To: **South Tyneside Council**
From: **Iceni Projects Ltd (Transportation)**
Date: **9th March 2016**
Title: **ST/0955/15/FUL - Former Be Modern Premises, Western Approach, South Shields**

a. Introduction

b. Response to STC Comments

A4. HGV SWEPT PATH ANALYSIS

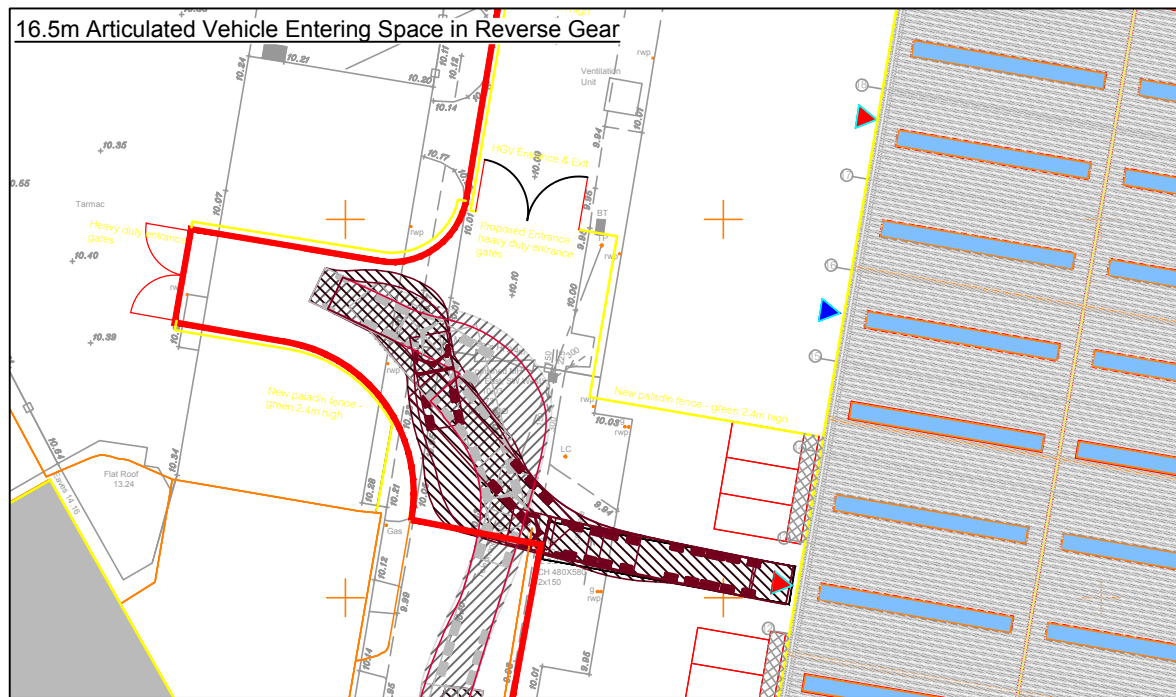
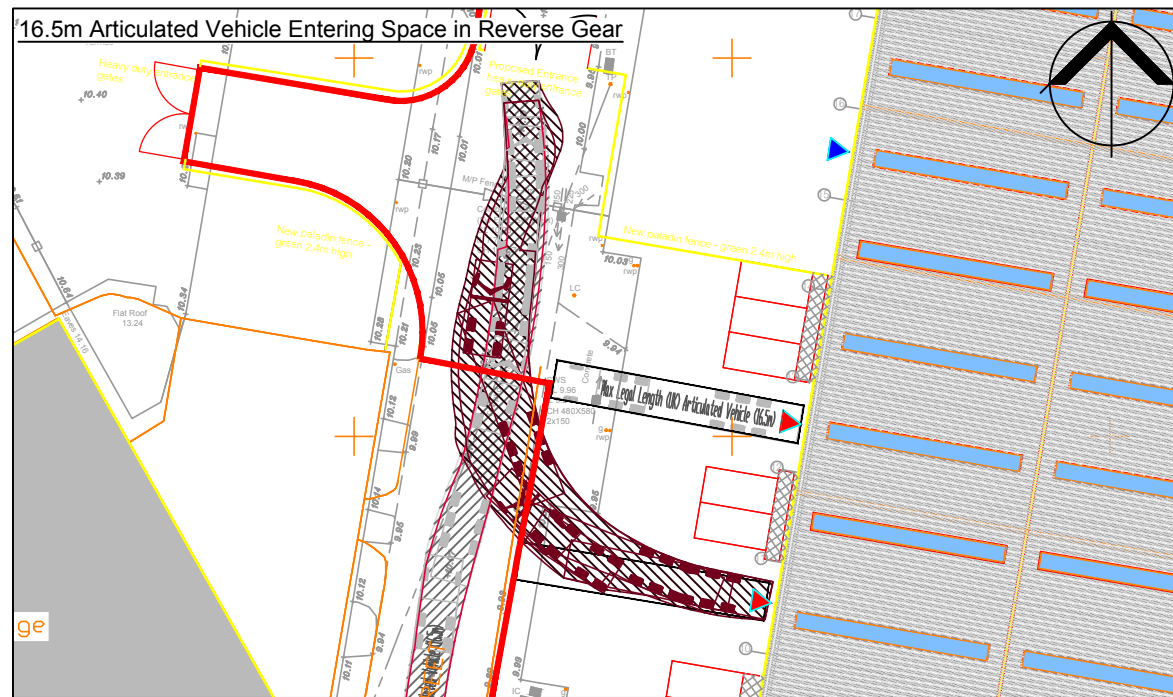
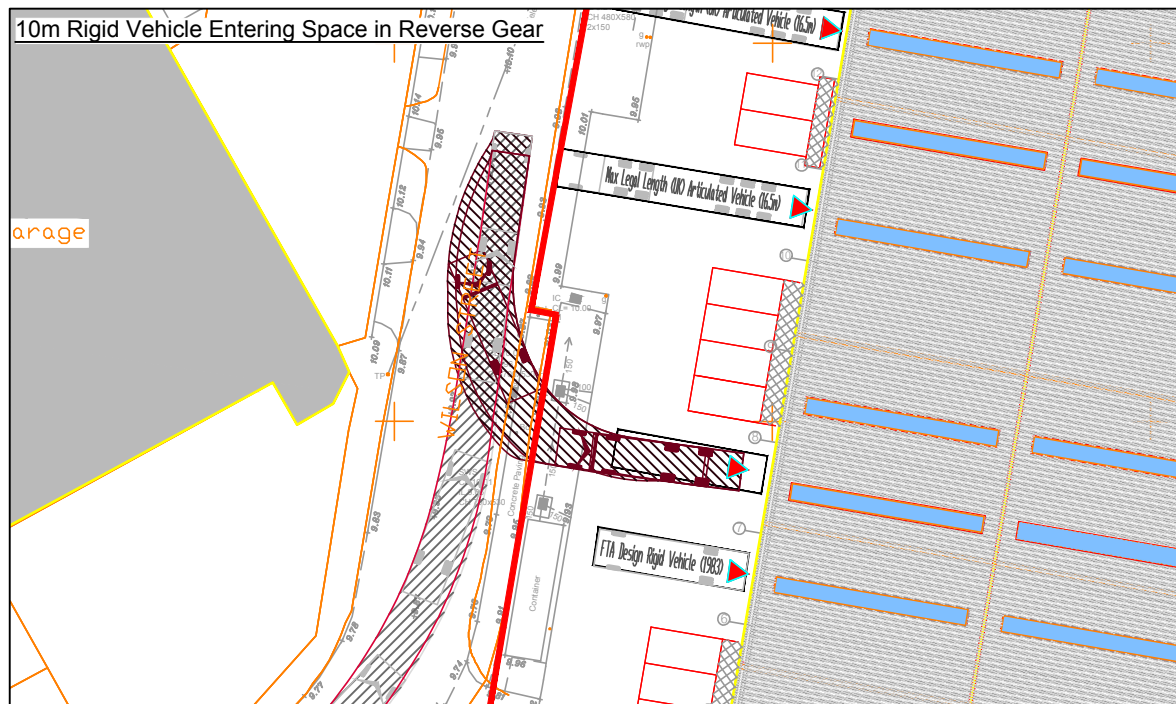
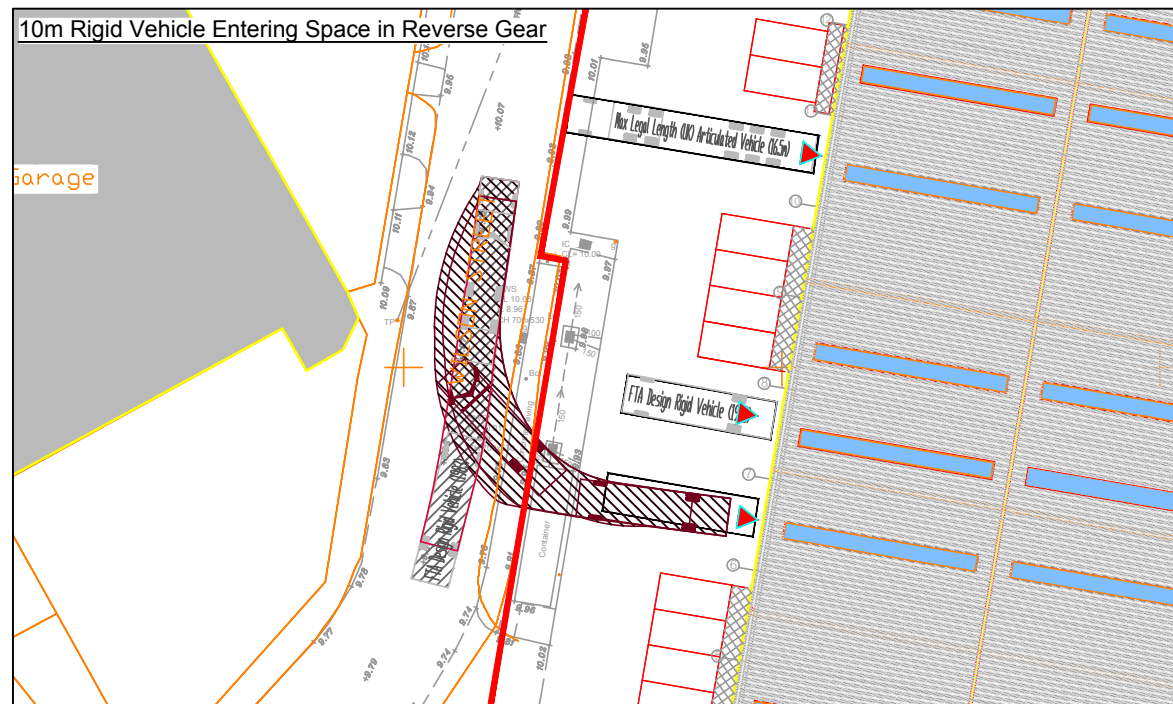
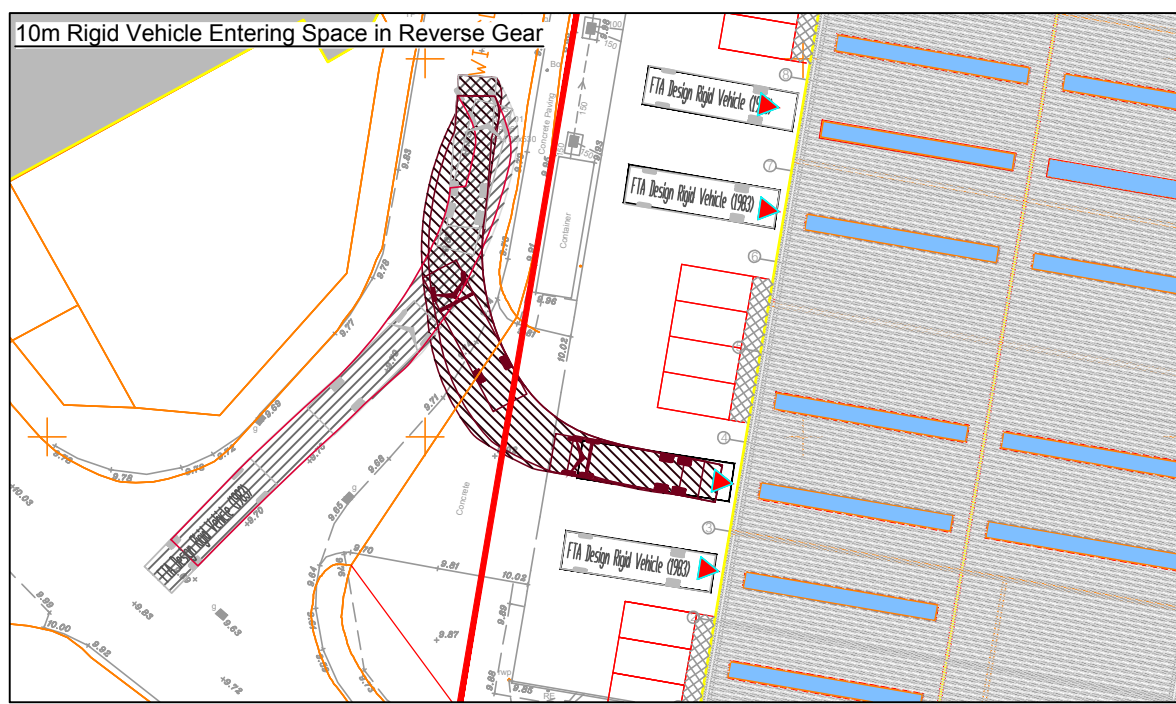
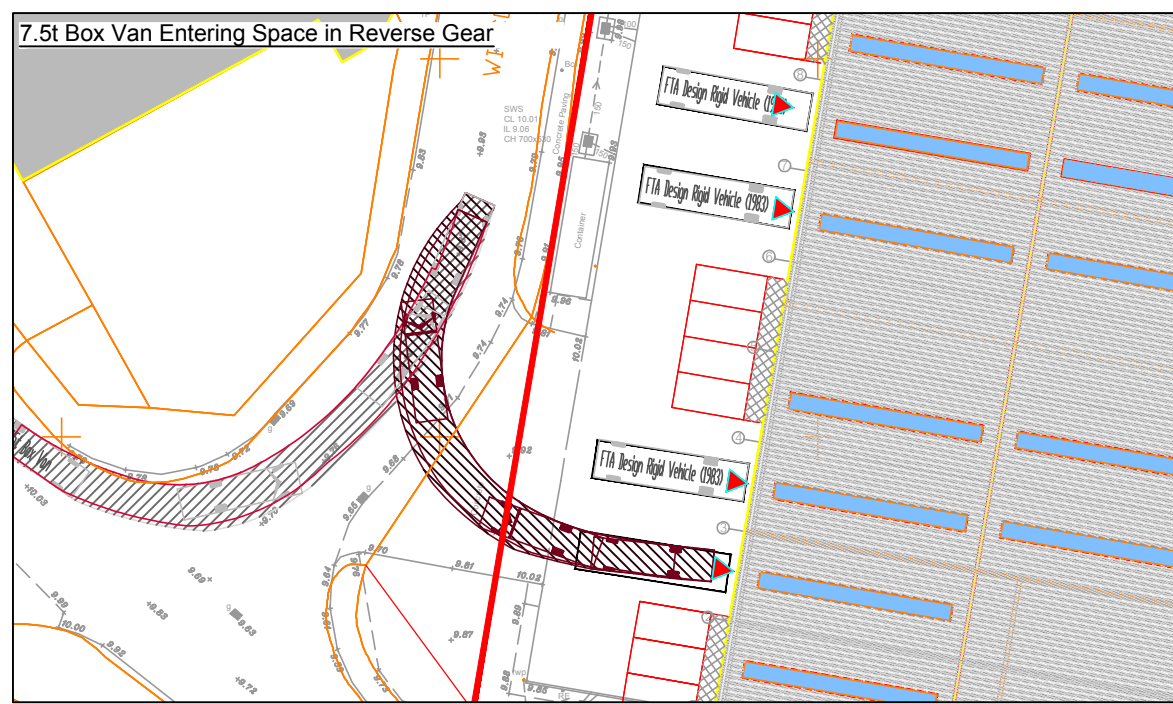
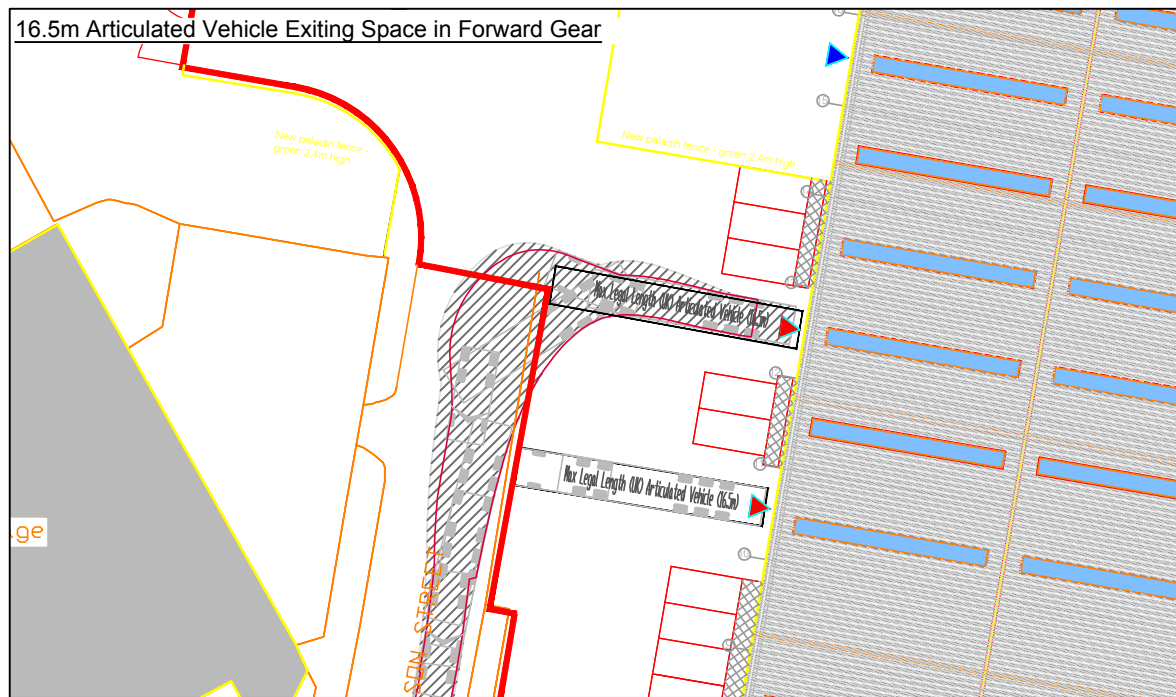
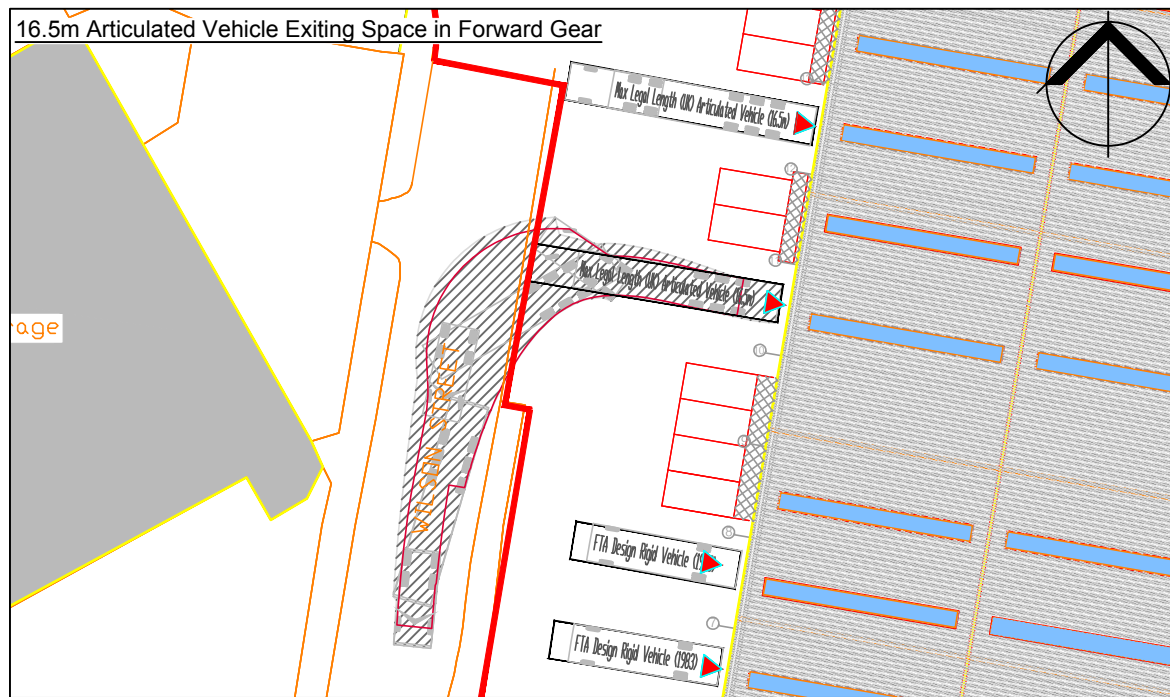
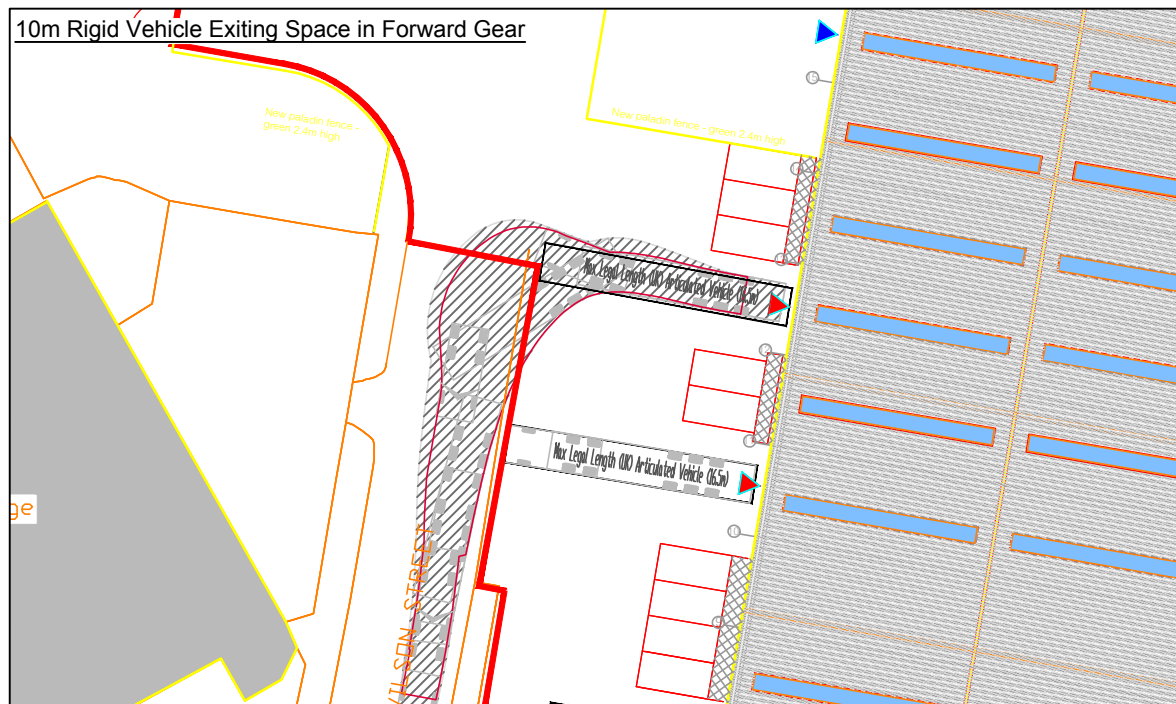
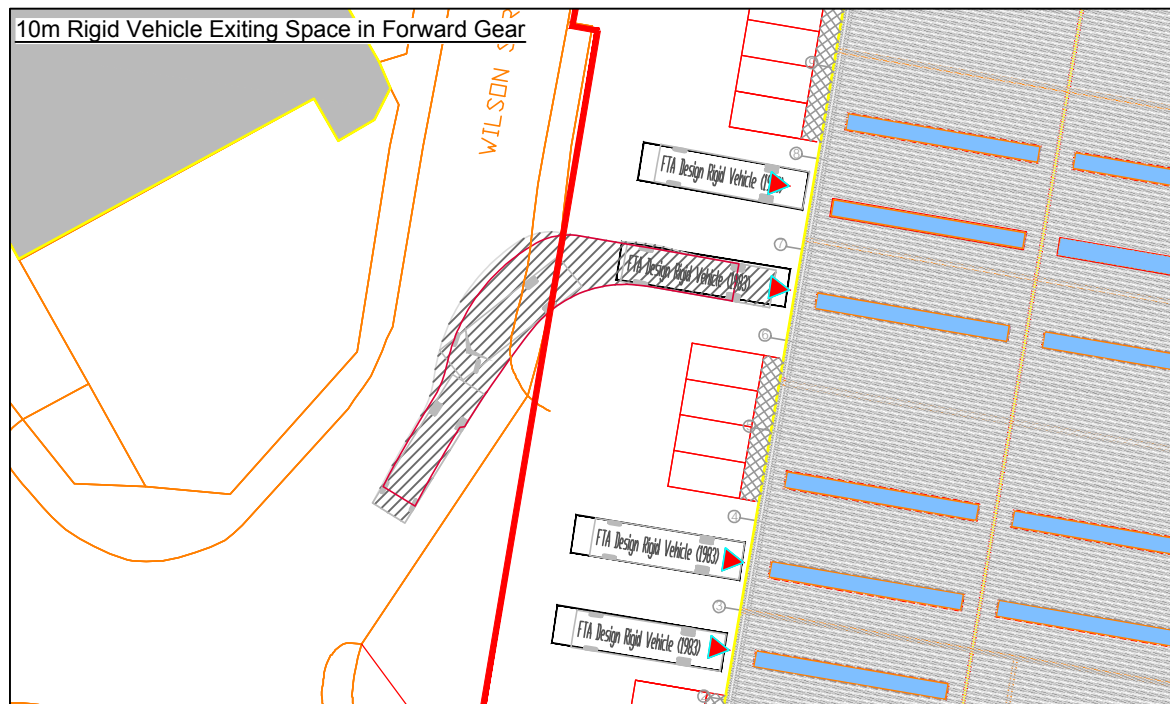
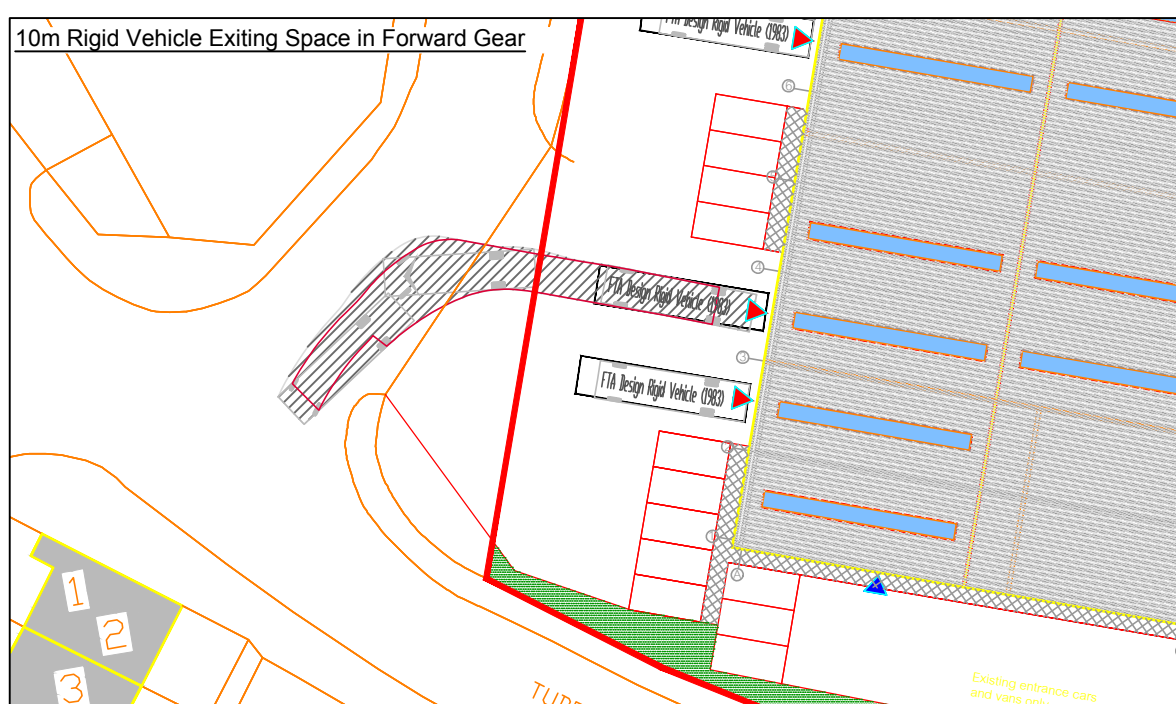
20. *Swept paths have not been produced for all units, can this be provided.*
21. Drawings showing the swept path for service vehicles servicing all units are included at Appendix A4. These show that all units can be accessed by the vehicles that will be servicing them even if a vehicle is parked at the adjacent loading door.
22. *The swept path produced for unit 2 shows that a 16.5m vehicle would need to use the Travis Perking yard (requiring the gates to be open). The analysis doesn't seem to make use of the turning head within the manoeuvre.*
23. The swept path for unit 2 has been redone utilising the turning head to manoeuvre. This is shown on the drawings included at Appendix A4.
